The Commission has issued the enclosed Amendment No. 78 to Facility Operating License No. DPR-46 for the Cooper Nuclear Station. This amendment consists of changes to the Technical Specifications in response to your application of December 31, 1981.

COOPER NUCLEAR STATION

Amendment No. 78
License No. DPR-46

SAFETY EVALUATION BY THE OFFICE OF NUCLEAR REACTOR REGULATION

Figure 3.11-1.1 Maximum Average Planar Linear Heat Generation Rate versus Exposure with LPCI Modification and Bypass Flow Holes Plugged, Initial Core Fuel Type 3.

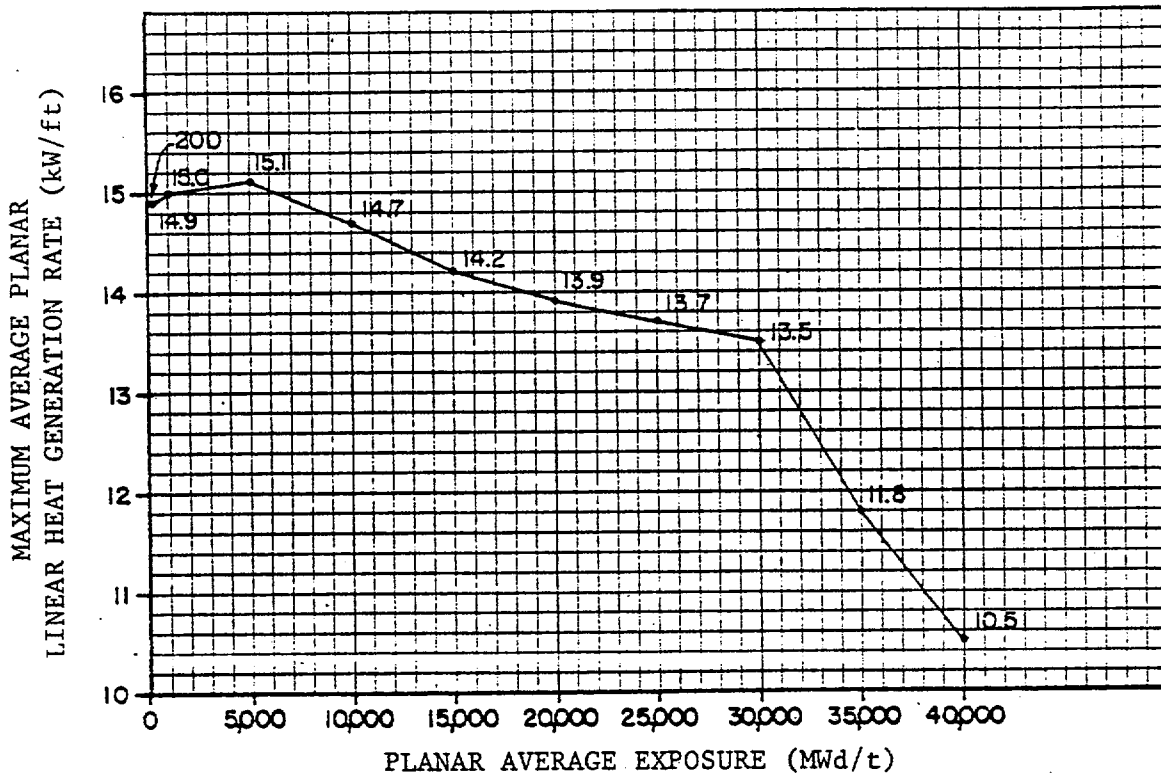
The amendment extends the Maximum Average Planar Linear Heat Generation Rate (MAPLHGR) limits for the 7x7 (types 2 and 3) and the 8x8 (types 8D250, 8D274L, P8DRB265L, 8DRB283, and P8DRB283) fuel assemblies for exposure values beyond the 30,000 megawatt days per short ton of uranium currently in the Technical Specifications to 40,000 megawatt days per short ton. The basis for this extension was provided in letters from R. E. Engel of General Electric to T. A. Ippolito of NRC dated May 6, 1981 and May 28, 1981 which were approved in a memorandum from L. S. Rubenstein (NRC) to T. M. Novak (NRC) dated June 25, 1981.

For 7x7 (types 2 and 3) and 8x8 (types 8D250, 8D274L, P8DRB265L, 8DRB283 and P8DRB283) fuel types the licensee proposed to extend the burnup time from 30,000 to 40,000 MWd/t. The licensee has stated (Ref. 1) that they comply with General Electric letters (Refs. 2 and 3) for the MAPLHGR limits. Therefore, as stated in Ref. 4, we find the proposed extended exposure MAPLHGR limits for these fuel types acceptable. The licensee's proposed generic MAPLHGR curves for these fuel types, which reduce the need for future cycle dependent revisions, have been done with currently approved calculational methods and are in compliance with Refs. 2 and 3; therefore, we conclude these revised curves are acceptable.
